VSP-75

VENDOR SERVICE PUBLICATION

SUBJECT: Avco Lycoming Service Letter No. L218 and Service Instruction
No. 1059C, No. 1110C and No. 1257E

DATE: April 10, 1987
Service Instruction No. 1110C
(Supersedes Service Instruction No. 1110B)
Engineering Aspects are
FAA Approved

Typical Adapter Installation

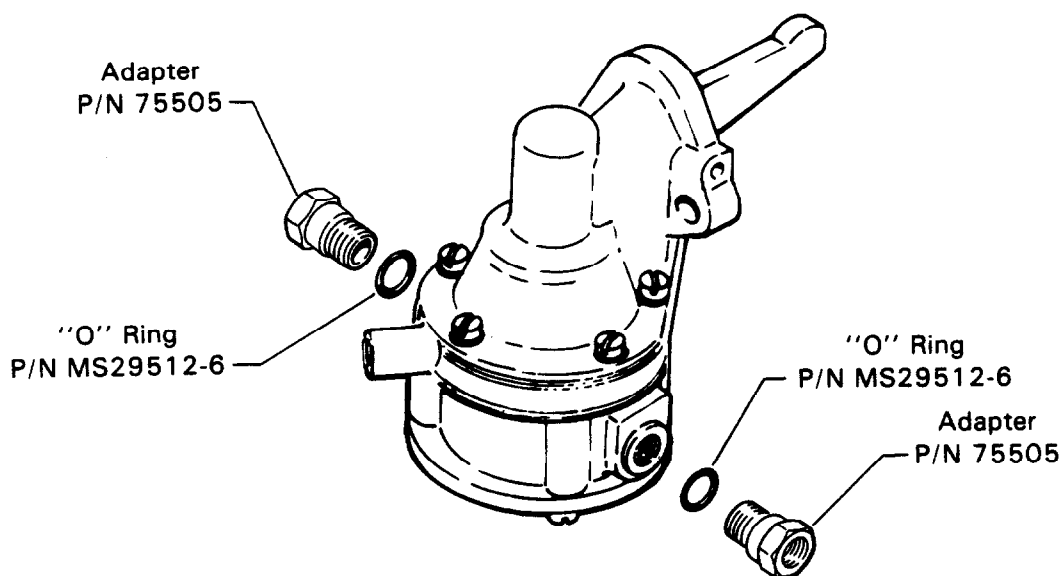
When replacing certain older AC diaphragm type fuel pumps, AC P/N 40174 or P/N 56999 (tapered pipe thread inlet and outlet ports) with a new pump incorporating straight thread ports, an adapter P/N 75505 is available to adapt the pipe thread fittings to the new pump. All newer types of fuel pumps incorporate straight thread ports.

When the older model fuel pumps are replaced with new models, 2 Adapters P/N 75505 and 2 "O" Rings P/N MS29512-6 (one for each adapter) must be ordered separately for proper installation.

Figure 1.
Carburetor Showing Area to be Machined

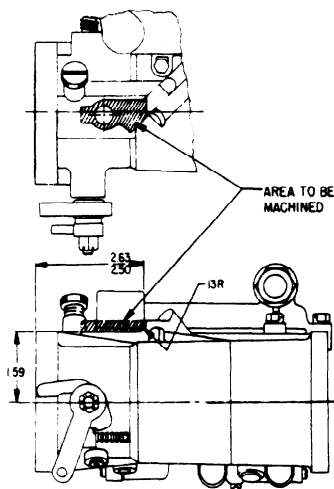
Because of the increased size of the new AC fuel pumps, certain engine models using P/N LW-16335 fuel pump with rear mounted carburetors must have the carburetor reworked to remove the back suction economizer boss. (If not already accomplished or prior to installation of new P/N LW-16335 fuel pump.) See Table 1. Using suitable equipment machine this boss as shown in Figure 1. Also, because of the increased size of the new fuel pump, certain dual magneto engine models must have the accessory housing reworked. See Table 2. Again, using suitable equipment, machine the boss on the accessory housing as shown in Figure 2.
